NUCLEAR REGULATORY COMMISSION

Title: Advisory Committee on Reactor Safeguards
Thermal Hydraulics Subcommittee

Date: Thursday, February 16, 2006

Test Apparatus Schematic

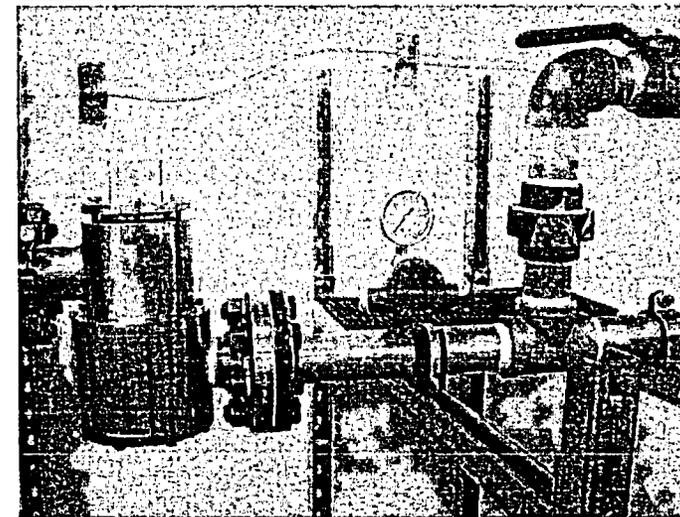
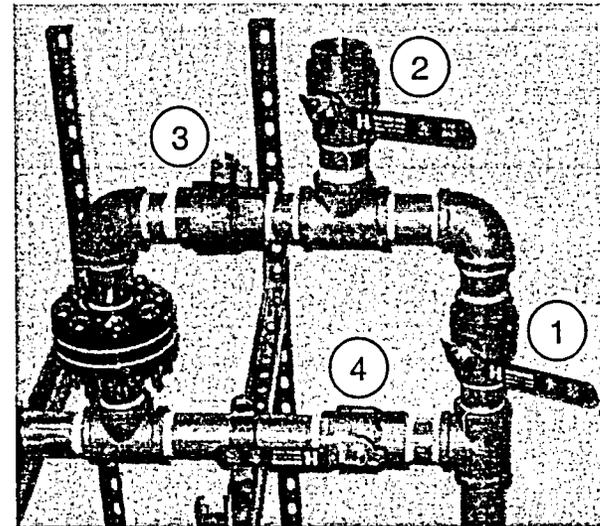
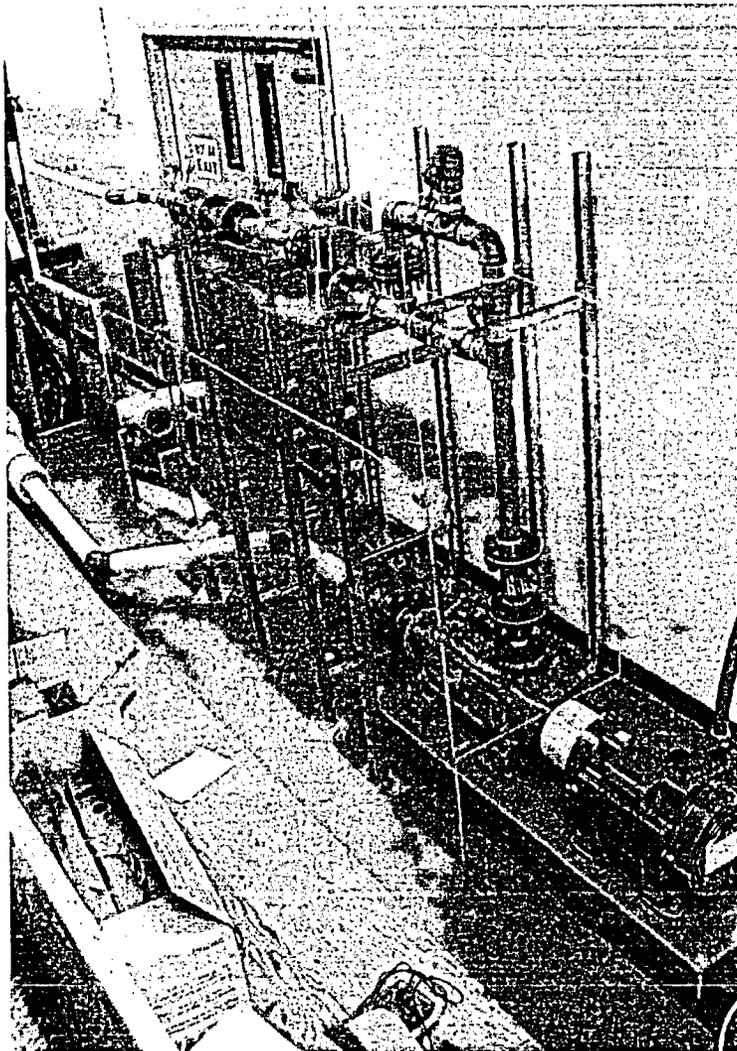
16 MR. LETELLIER: On slide number six, it
17 will show you the manifold.

Surrogate Valve Design

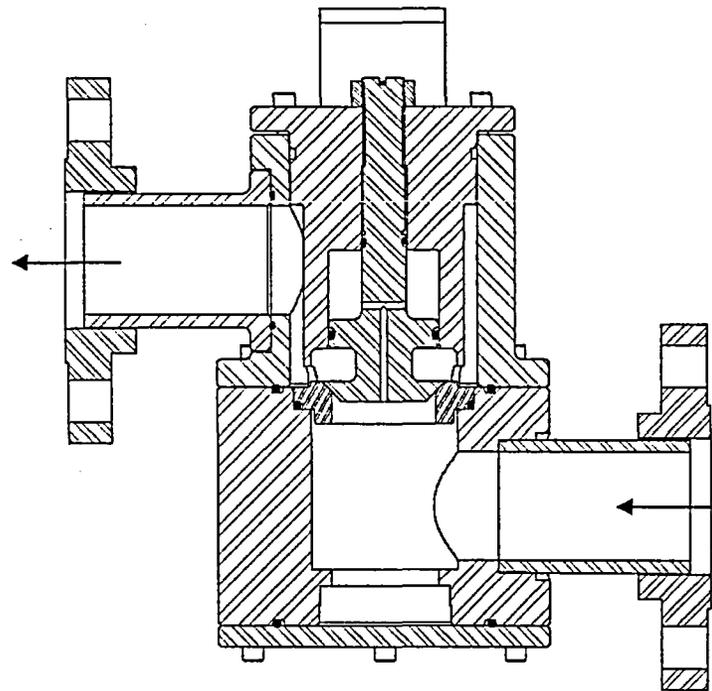
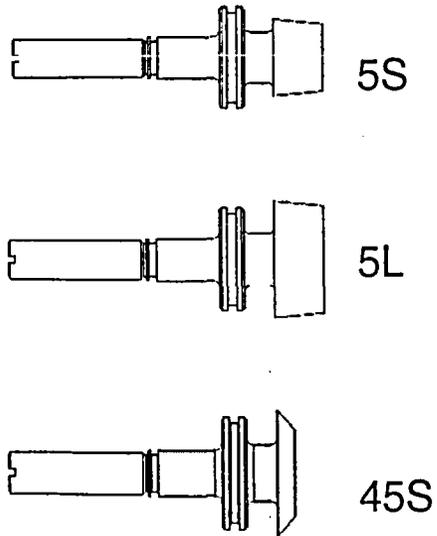
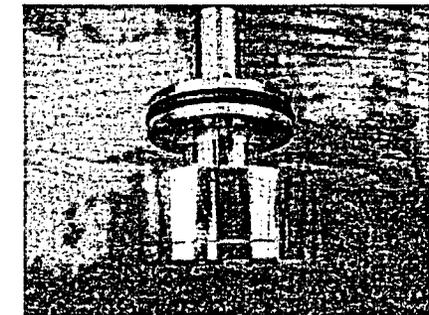
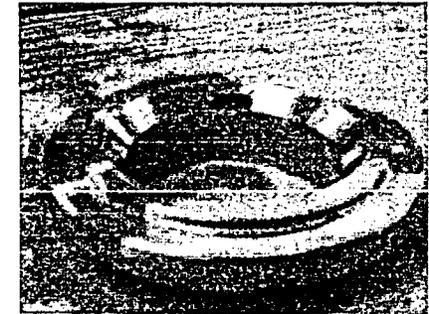
19 There is a typographical error, you want
20 to change this annotation to 45 large at the bottom,
21 and it simply means that the diameter of the two large
22 stems are identical, but the angles are not.

3 DR. KRESS: Yes, on the outlet side, on
4 Figure 2, the annulus.

Single Debris – RMI

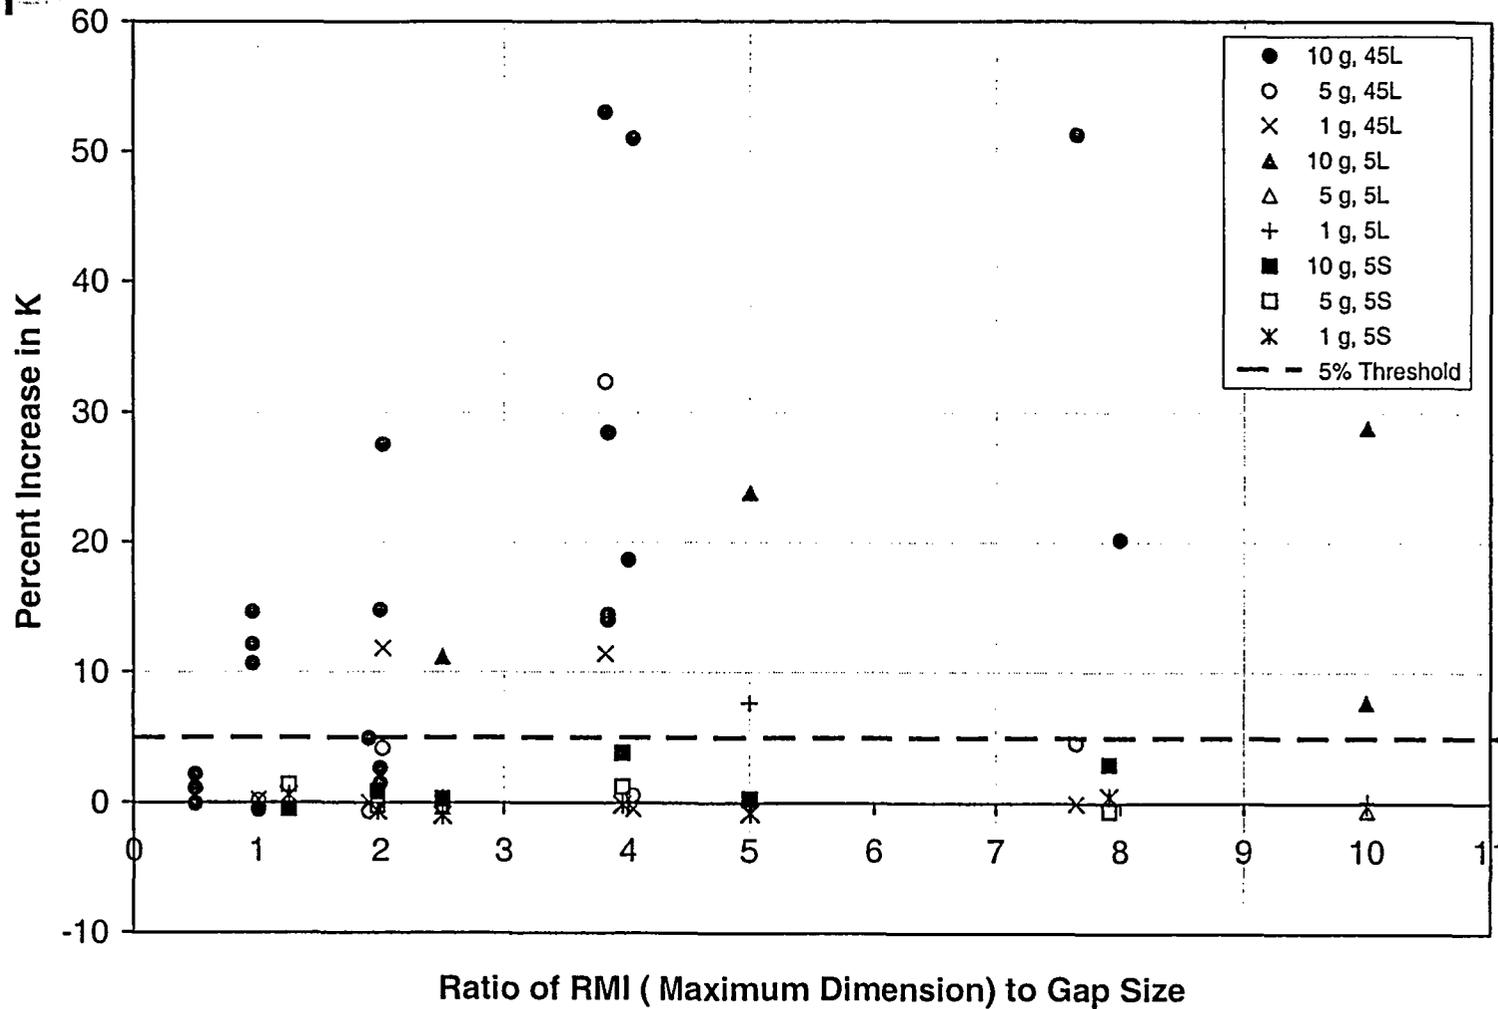
3 One trend of interest to note in this
4 figure, if you focus on the solid square symbols,
5 which represent the smaller diameter five degree stem,
6 they are all in the lower percentages of pipe loss
7 coefficients.

8 This goes back to the questions of
9 internal flow. For some reason, this configuration
10 performs much better in all cases as we go through,
11 you will see that the smaller diameter channels the
12 flow in some way that tends to clear the debris better
13 than the others.

Single Debris – NUKON

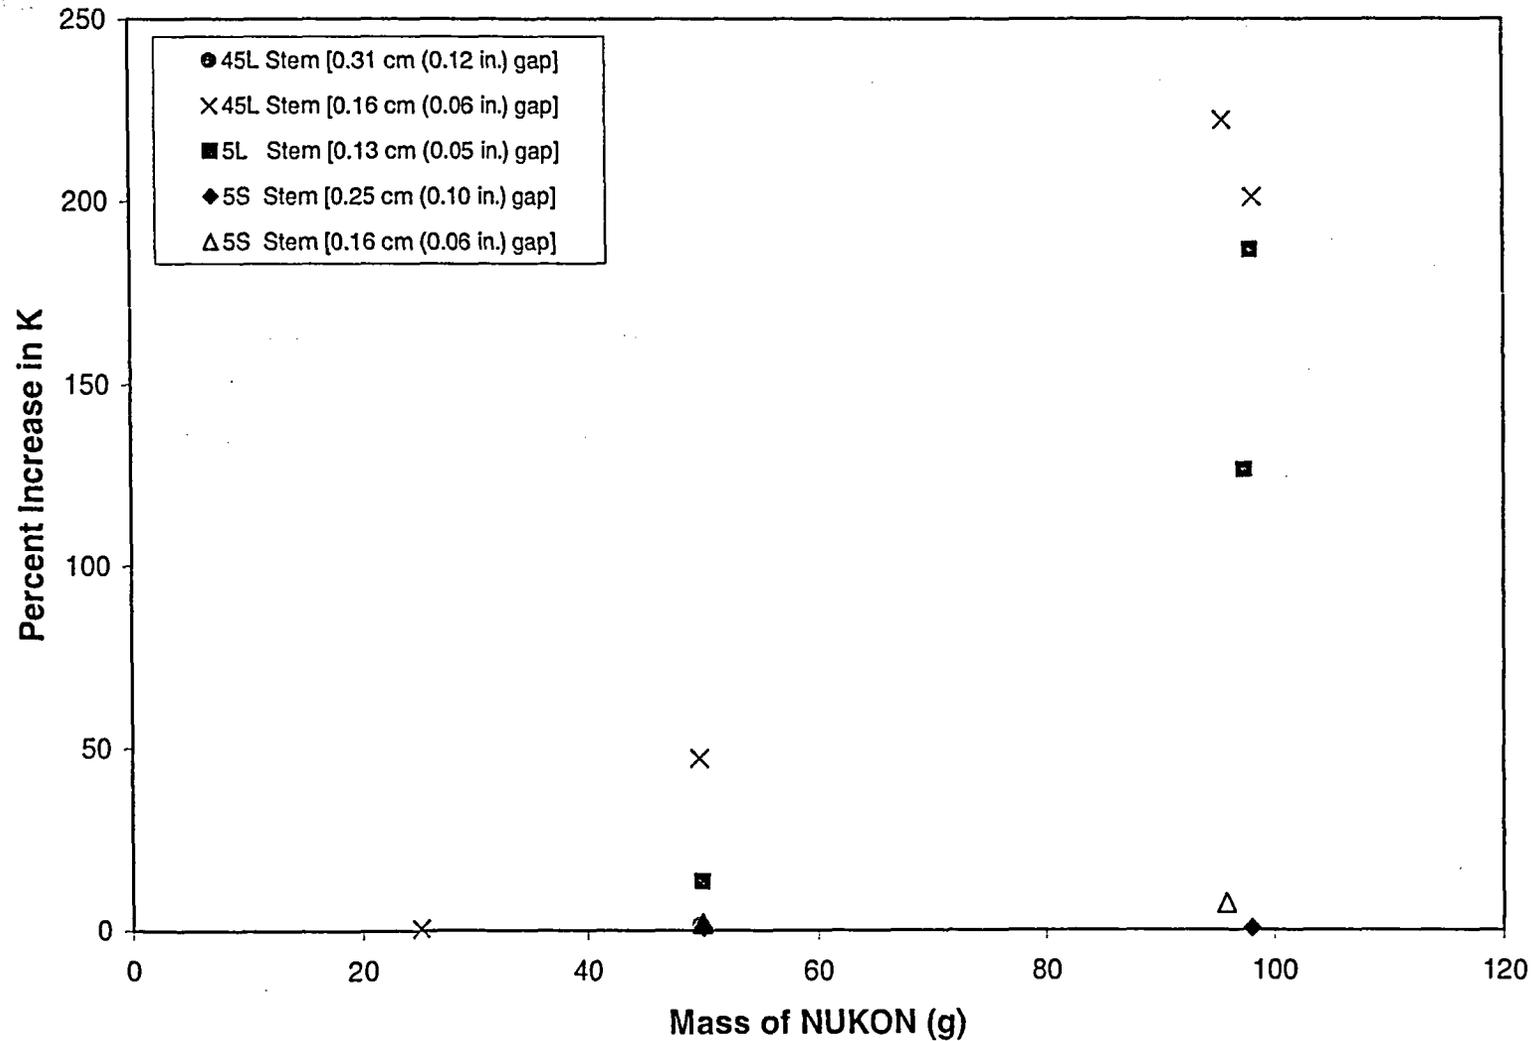
11 DR. BANERJEE: Yes, but even if you look
12 at NUKON, the 5F series show a much lower percentage
13 increase in K. So, what you saw with RMI you see with
14 NUKON as well. So, it seems that there's something
15 interesting if you look at those diamonds and those
16 triangles.

Alternate Flow Path

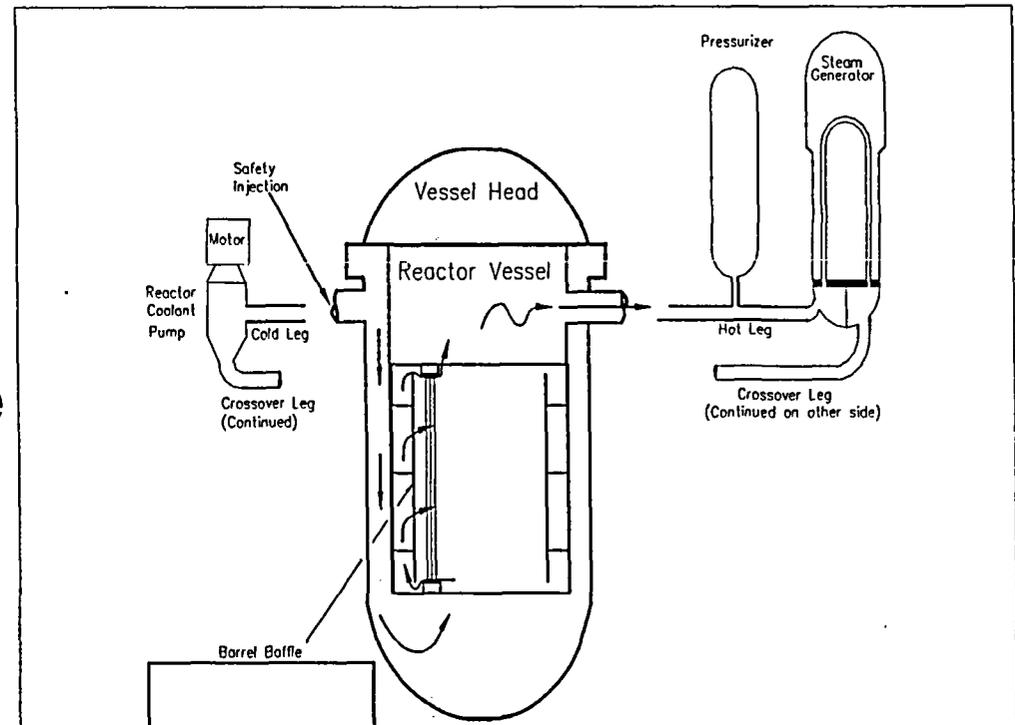
1 debris screens on the bottom of the fuel, okay, to try
2 to catch debris during normal operation to avoid
3 having it come up into the core region? If you
4 already have these other inch and a half holes all
5 over the place that provide lots of bypass flow into
6 the core region, why do you need debris screens on the
7 bottom of the fuel bundles?

12 DR. BANERJEE: I guess Ralph's question
13 is, if you get this cross flow, and it brings debris
14 in, it will just deposit it in an outer ring, and the
15 inner fuel --

10 And, the reason the holes are there is to
11 provide, during an upset condition where you
12 depressurize the reactor quickly, pressure release
13 yield implode or explode the baffle barrel region.
14 You know, it's not a main flow path under normal
15 operating conditions.
